2.5 Geology, Seismology, and Geotechnical Engineering

In Section 2.5, "Geology, Seismology, and Geotechnical Engineering," of the SSAR, SERI provided a detailed description of the geological, seismological, and geotechnical engineering properties of the ESP site. In this SER, Section 2.5.1, "Basic Data," describes basic geological and seismological data, especially the data published since 1986 for the area within a 200-mile radius of the ESP site, and presents updated seismic sources. Section 2.5.2, "Vibratory Ground Motion," evaluates the vibratory ground motion for the ESP site and analyzes the safe-shutdown earthquake (SSE) ground motion. Section 2.5.3, "Surface Faulting," describes the potential for surface faulting at or near the surface of the ESP site. Section 2.5.4, "Stability of Subsurface Materials and Foundations," presents the results of site geotechnical investigations and discusses the stability of subsurface materials and foundations. Section 2.5.5, "Stability of Slopes," defers the analyses for slope stability at the site and dam performance, respectively, to the COL stage. Finally, Section 2.5.6, "Embankments and Dams," briefly states that no embankments exist wi

Figure 2.5.2-1 (SSAR 2.5-57) Deaggregation for low-frequency (S_a 1–2.5 Hz) ground motions at the GGNS ESP site

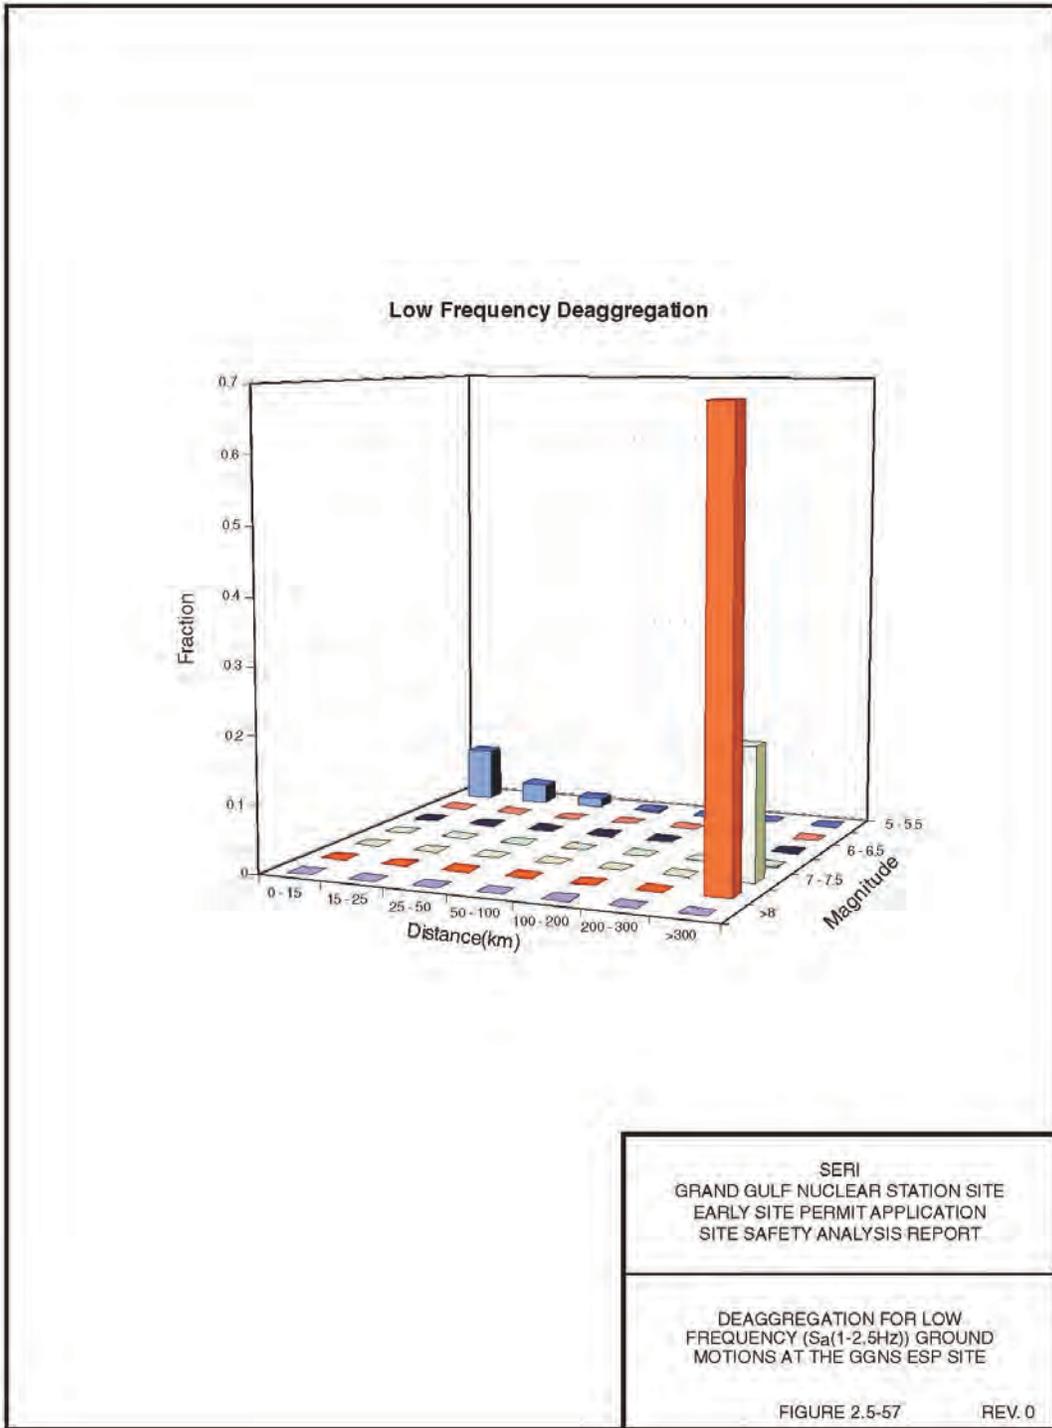
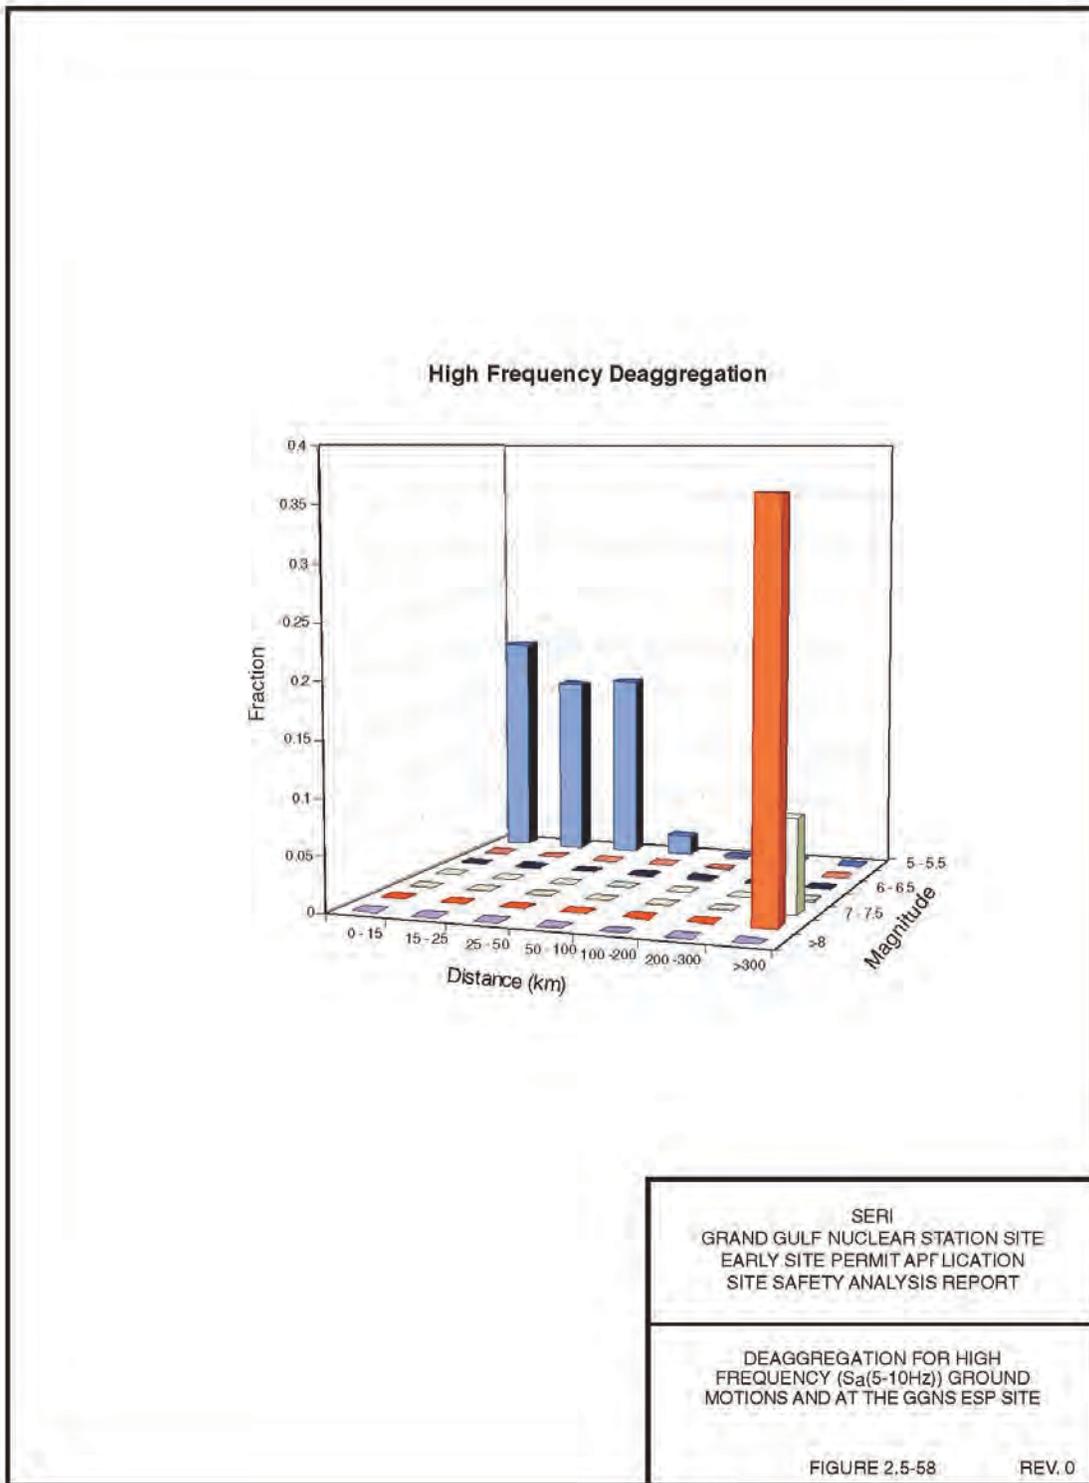
In RAI 2.5.2-9, the staff asked the applicant to explain why the SRSZ, with a magnitude as large as 6.0–7.0 and a distance at 81–206 miles, makes no contribution to the deaggregation results. In its response, the applicant stated the following:

In RAI 2.5.2-9, the staff asked the applicant to explain why the magnitude and distance bins corresponding to the SRSZ make no contribution to the deaggregation result, although the SRSZ maximum earthquake magnitude is as large as 6.0–7.0 and at a distance of 81–206 miles from the ESP site. The applicant stated that the overall rate of earthquake occurrence (M_w greater than 5) at these distances for the SRSZ was too low to contribute to the 10^{-5} median hazard. However, the staff notes that in SSAR Section 2.5.2.1.3 and in its response to RAI 2.5.1-3, the applicant stated that the activity of the SRSZ has a probability of 0.5 for its existence. This probability of existence implies that the SRSZ has a 50 percent chance to produce an earthquake with a magnitude between 6.0–7.0. The applicant also assigned three different return periods (388, 1725, and 3505 years) to the characteristic SRSZ earthquake model based on paleoliquefaction data. As such, a SRSZ earthquake with a 3,505-year return period should repeat about 30 times during the 100,000-year time span that is associated with a 10^{-5} probability of exceedance. Therefore, the staff was not certain why the magnitude and distance bins corresponding to the SRSZ do not contribute to the hazard at the 10^{-5} probability level.

After reviewing the applicant's response, the staff concluded that it does not adequately address the absence of the SRSZ's contribution to the deaggregated seismic hazard at the ESP site. The absence of the hazard contribution from the SRSZ is probably due to the applicant's computational procedure for this particular seismic zone, which has a 0.5 probability of activity. To confirm this conclusion, the staff performed an independent evaluation using seismic sources similar to those used by the EPRI-SOG for the ESP site. For its evaluation, the staff also used a source weighting scheme similar to that used by EPRI -SOG and added a new source similar to the SRSZ. The staff then calculated and deaggregated its seismic hazard using two methods. The first method, which is the method adopted by the applicant model, resulted in no contribution from the SRSZ to the deaggregated seismic hazard result. The second method resulted in the appearance of a contribution from the SRSZ to the site hazard. The second method differs from the first one in that, instead of using those magnitude and distance bins associated with a 0.5 probability of non-activity in the deaggregation, they were omitted from the calculation. Implementing the second approach, the combined contribution from all relevant magnitude (M 6-6.5, M 6.5-7 and M >7.0) and associated distance bins are about 10 percent relative seismic hazard contribution for 5 and 10 Hz and 5 percent for 1 and 2.5 Hz, respectively. The staff's evaluation suggests that the SRSZ missing hazard contribution is from the applicant's computational procedure because more than half of the hazard values in the corresponding magnitude and distance bins for the corresponding non-activity logical tree branches are zeros. The staff asked the applicant to reevaluate the seismic hazard contribution from the SRSZ based on the staff's findings since the result could potentially affect the determination of the controlling earthquakes, and thus the determination of the SSE.

The purpose of the magnitude-distance deaggregation is to provide a measure of the relative contribution of events (of different magnitude-distance pairs) to the total hazard. The deaggregation graphs in the SSAR show the relative contribution of earthquakes to the 10^{-5} median. The fact that events associated with the Saline River source (and all sources in this distance range) do not contribute to the 10^{-5} median hazard for the Grand Gulf site is primarily due to the fact that the overall rate of earthquake occurrences ($M_w > 5$) at these distances is extremely low. Further, the rate of occurrence of earthquakes of magnitude 6.0–7.0 is thus much lower. The result is that the estimated ground motion hazard at the Grand Gulf site is extremely low and, in a relative sense, makes little or no contribution to the 10^{-5} median hazard.

In response to the staff's evaluation, the applicant performed a sensitivity test to evaluate the impact of the missing SRSZ contribution to the controlling earthquakes. When increasing the hazard contribution from the SRSZ, the applicant balanced the total hazard by decreasing the hazard contribution from other sources, including the NMSZ, which ensured the NRC staff that the absence of the SRSZ contribution only caused by the applicant's deaggregation process. The applicant stated that the results from the sensitivity test indicate there is a very small change to the 5 and 10 Hz controlling earthquakes (see Table 2.5.2 -1) and associated median rock response spectrum. The calculated differences in response spectrum values ranges from +0.06 to -0.23 percent of the comparable Grand Gulf response spectra. The applicant concluded that even if the staff's approach were used to deaggregate the controlling earthquake, which shows that the SRSZ may contribute up to 5 to 10 percent of the median hazard, the contribution would not result in a significant change to the median rock ground motion at the Grand Gulf site. Based on the results of the applicant's sensitivity test and also the fact that the SRSZ is relatively far from the ESP site (130 to 329 km), the staff concurs with the applicant on its conclusion with regard to the specific situation of the ESP site. Therefore, this open item is resolved.
